APPLICATION NO.	FILING DATE	FIRST NAMED INVENTOR	ATTORNEY DOCKET NO.	CONFIRMATION NO.
09/972,942	10/10/2001	Nobuyuki Suda	Q65006	4815

Office Action Summary

DETAILED ACTION

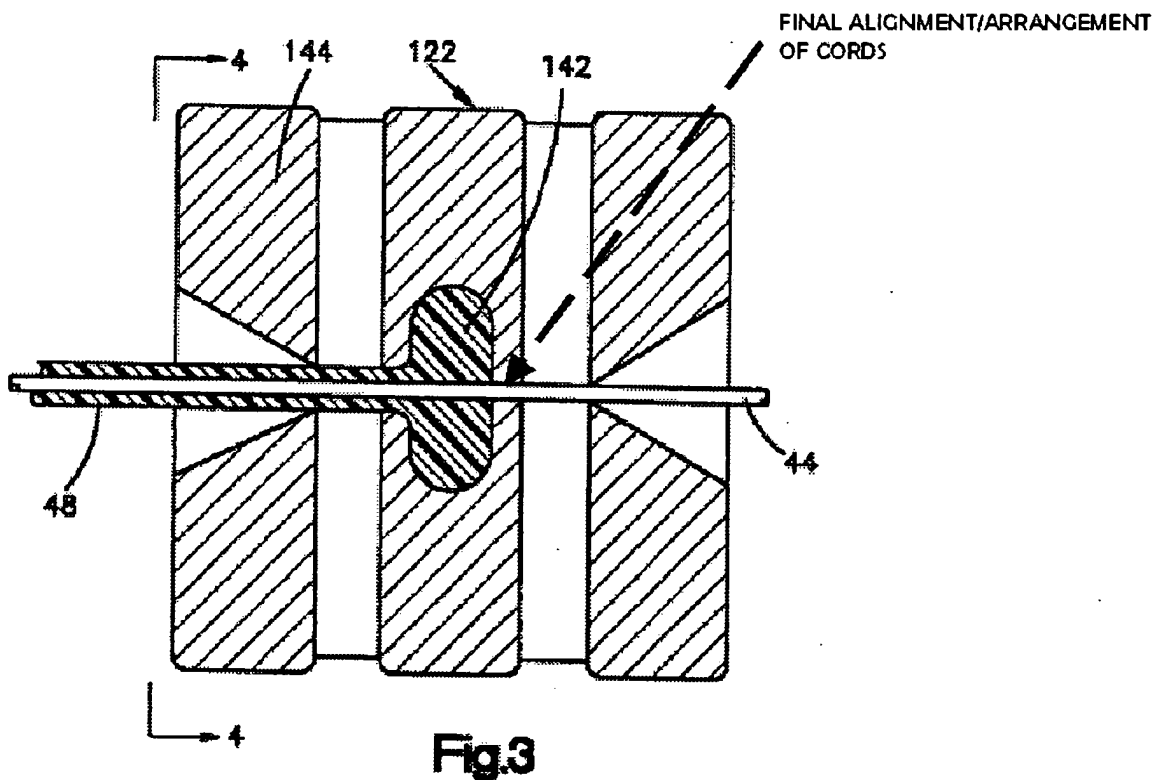
Although not explicitly taught by Vinson et al., the final alignment/arrangement of the cords is accomplished immediately before coating by a narrow passageway/insertor in the extrusion head/die (see Fig. 3 below). The final alignment/arrangement of the cords is evidenced by the linear

spatial separation of the cords as shown in Fig. 4. Alternatively, the breadth of the limitation "immediately after" is also able to be interpreted as "the following step/process without any steps between arrangement and coating" which is inherently met by Vinson et al.

The area of the structure (element 122) where the final alignment/arrangement of the cords takes place acts as the instantly claimed "inserter" since the cords are passed through this structure or passageways and arranged in line as set forth above.
